DUANE ARNOLD ENERGY CENTER

AMENDMENT TO FACILITY OPERATING LICENSE

Amendment No. 98
License No. DPR-49

ATTACHMENT TO LICENSE AMENDMENT NO. 98

DUANE ARNOLD ENERGY CENTER IOWA ELECTRIC LIGHT AND POWER COMPANY TECHNICAL SPECIFICATIONS
LIMITING AVERAGE PLANAR LINEAR HEAT GENERATION RATE AS A FUNCTION OF PLANAR AVERAGE EXPOSURE FUEL TYPE: 8D274L FIGURE 3.12-5

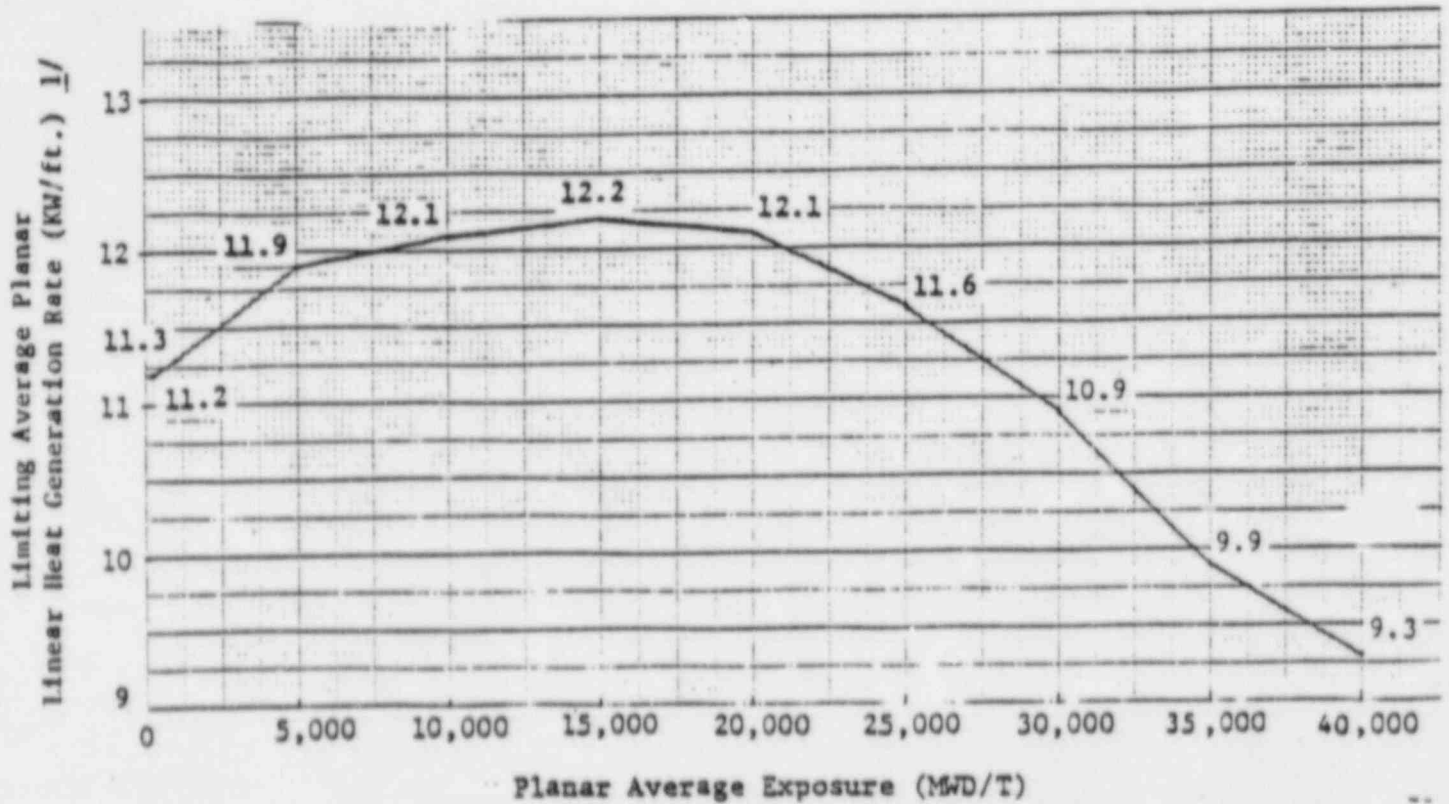
1/ When core flow is equal to or less than 70% of rated, the MAPLHGR shall not exceed 95% of the limiting values shown.

DUANE ARNOLD ENERGY CENTER IOWA ELECTRIC LIGHT AND POWER COMPANY TECHNICAL SPECIFICATIONS
LIMITING AVERAGE PLANAR LINEAR HEAT GENERATION RATE AS A FUNCTION OF PLANAR AVERAGE EXPOSURE FUEL TYPE: 8D274H FIGURE 3.12-6

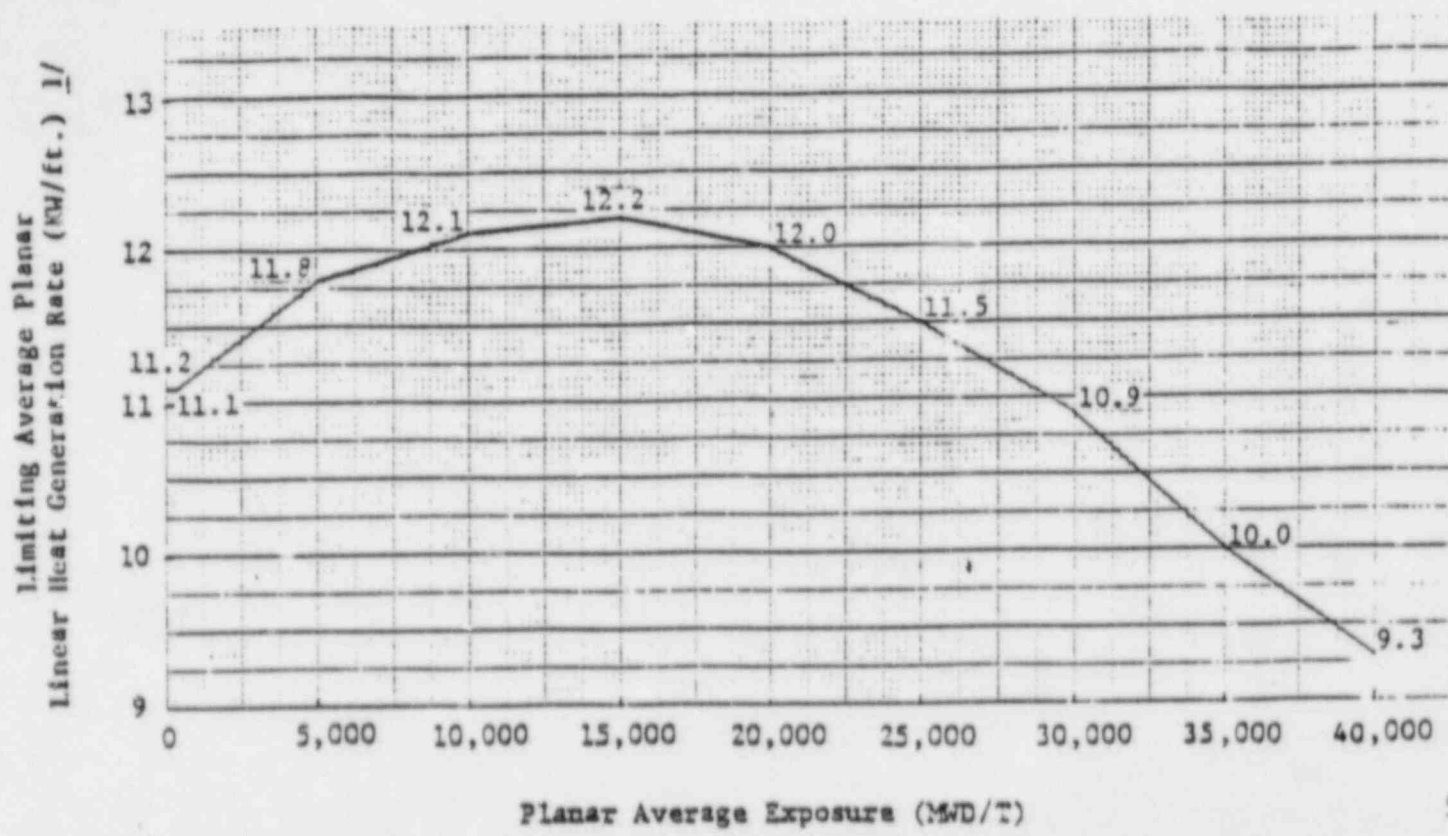
1/ When core flow is equal to or less than 70% of rated, the MAPLGR shall not exceed 95% of the limiting values shown.

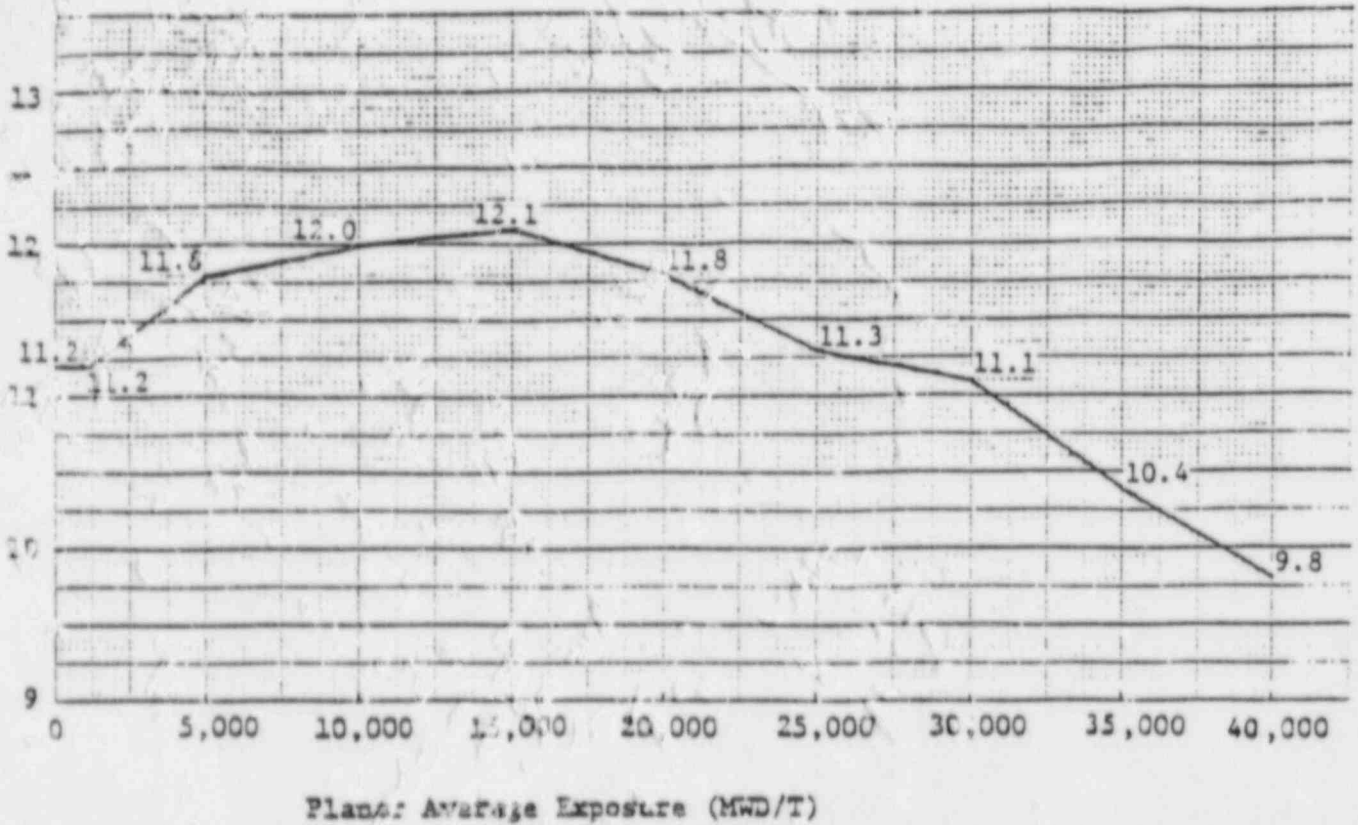
^{1/} When core flow is equal to or less than 70% of rated, the MAPLEGR shall not exceed 95% of the limiting values shown.
